VOLUME IX

JOHN F. RIDER

Emerson Chassis C

Emerson C134LW, C136LW, C138LW, C139LW, C140LW and C142LW

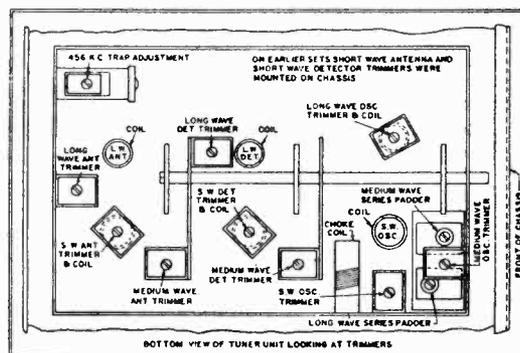
The schematic is the same as is given in *Rider's Vol. VII, page 7-36*, with the exception that C11 is a 0.00005-mf. fixed condenser shunted by a trimmer, C50, which is part of the long-wave coil assembly. The r-f. primary of T5, position 2, is shunted by a fixed condenser of 0.0001 mf. (C45), and a 2000-ohm resistor (R30).

The Long-Wave band has been substituted for the Police band in position 2. T2 is a long-wave antenna coil, T5 is the long-wave detector coil, and T8 is the long-wave oscillator coil.

C6 and C9 trimmers were supplied separately and later incorporated as part of SW Antenna and Detector coil assemblies.

Fig. 1. Schematic of the power pack and filter used in Philco Models 511 and 521. The condenser values for each model can be found in Figs. 1 and 3 above.

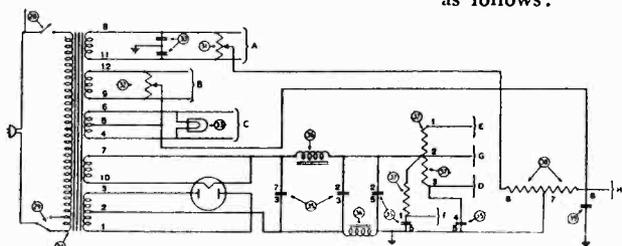
A change in the wiring has been made. The primary of the third r-f transformer instead of going to the left side of the resistor No. 17 now is connected to the other end. Plate voltage for the r-f tubes obtained from the point marked "D" in the voltage divider, No. 37, now is fed in to the resistors Nos. 7, 12, and 17 through

the left end of this combination immediately below the first r-f tube. The primary of this r-f transformer now is connected to the right side of No. 7 in the schematic. In other words, the lead marked "D" at the right end of the three series resistors now is at the left end.

Fig. 1 of the power pack and filter carries various numberings, which correspond to those of Figs. 2 and 3 and show the capacity values of the filter condenser packs No. 35 used for model 511 and 521 respectively. Note that the connections of the 1-mf condenser, 4-5, have been changed from the way they are shown in the schematic on page 8-107. Instead of terminal 4 of No. 35 being connected to terminal 3 of No. 37 it is connected to terminal 1 of No. 35.

The addition of the two resistors reduce the battery drain in Sentinel Model 65B.

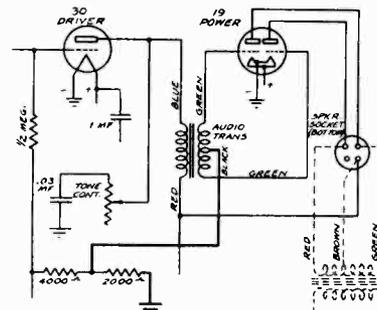
The "B" battery drain of the early production of Model 65B sets can be reduced by about 20% and a corresponding increase in battery life obtained by adding the 2000-ohm and 4000-ohm resistors as shown in the accompanying partial schematic. It is also necessary to change the connection of the black wire, which is shown going to ground from the tap on the sec-

ondary of the output transformer on page 8-27 in *Rider's Volume VIII*. This ground connection is changed to the junction of the two resistors mentioned above. This change puts a 3-volt bias on the 19 tube and reduces the "B" battery drain to 18-20 ma.
